SCAUWG CHART MASTER Candace Robinson

The following are her recent reports:

LOS ANGELES TERMINAL AREA CHART *** CHANGES *** The new edition of the Los Angeles Terminal Area Chart became effective May 19, 2022, and is valid until July 14, 2022. The following changes have been found:

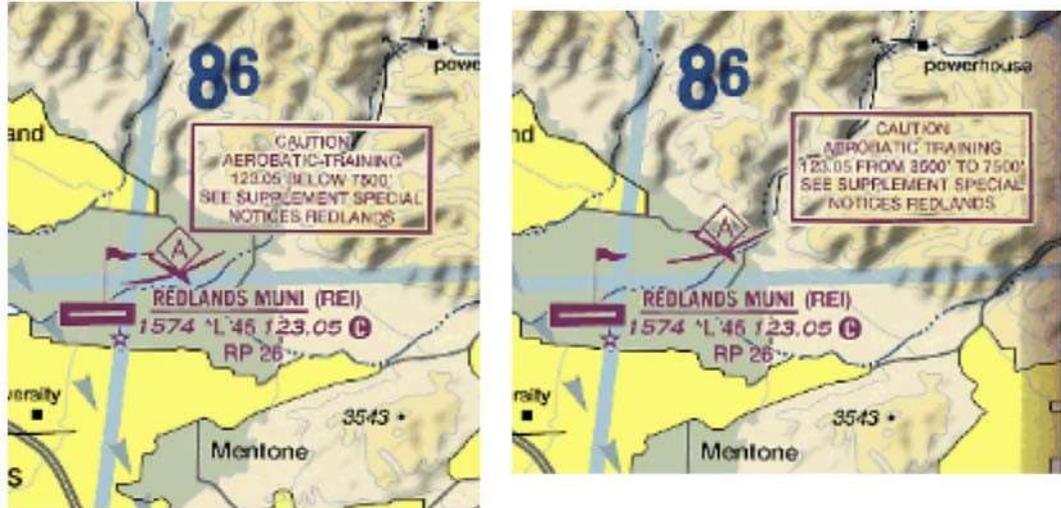
- Redlands aerobatic warning box and aerobatic symbol were moved approximately one nm to the northeast. The wording in the caution box was changed from:

CAUTION AEROBATIC TRAINING 123.05
 BELOW 7500 SEE SUPPLEMENTAL
 SPECIAL NOTICES REDLANDS

to

CAUTION AEROBATIC TRAINING 123.05 **FROM 3500'**
TO 7500'
 SEE SUPPLEMENTAL SPECIAL
 NOTICES REDLANDS

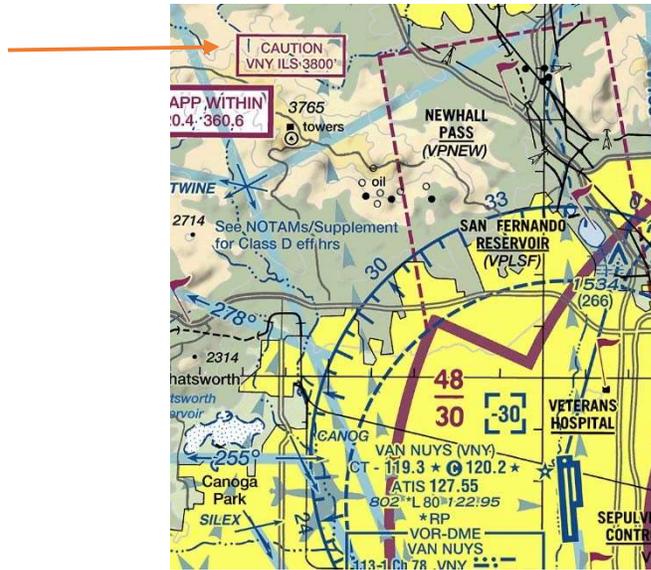
Long Beach Flying Club has received noise violations at LGB for VFR missed approaches outside the times permitted in the Airport Noise Compatibility Ordinance. It was pointed out to me that the listing for LGB in the Chart Supplement SW currently states:

Touch and go, stop and go, low apch only permitted 1500–0300Z \ddagger weekdays and 1600–2300Z \ddagger weekends and hol only on Rwy 08L–26R and Rwy 08R–26L.

It needs to be updated to:

Touch and go, stop and go, **practice** low apch, **VFR practice missed apch** only permitted 1500–0300Z \ddagger weekdays and 1600–2300Z \ddagger weekends and hol only on Rwy 08L–26R and Rwy 08R–26L.

AEROBATIC OPERATIONS NORTHEAST OF REDLANDS, CA

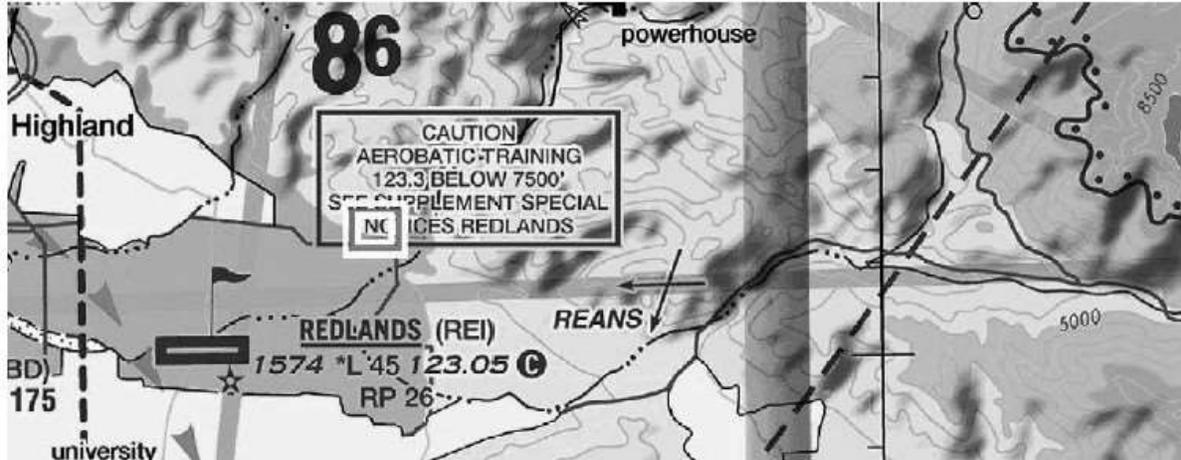
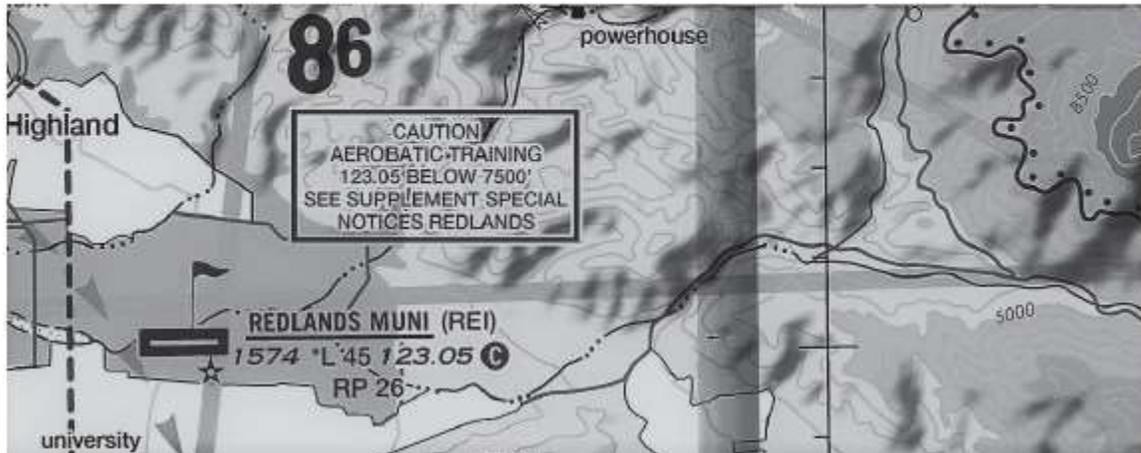
Normally, I don't track changes in the Chart Supplement, however I did notice that the previous edition of the CS the Special Notice, AEROBATIC OPERATIONS NORTHEAST OF REDLANDS, CA charted the information for the aerobatic area as follows:

The current edition of the Chart Supplement omitted the aerobatic box that had been charted within the caution box. This is probably due to the recharting of Redlands (REI) to Redlands Muni (REI).
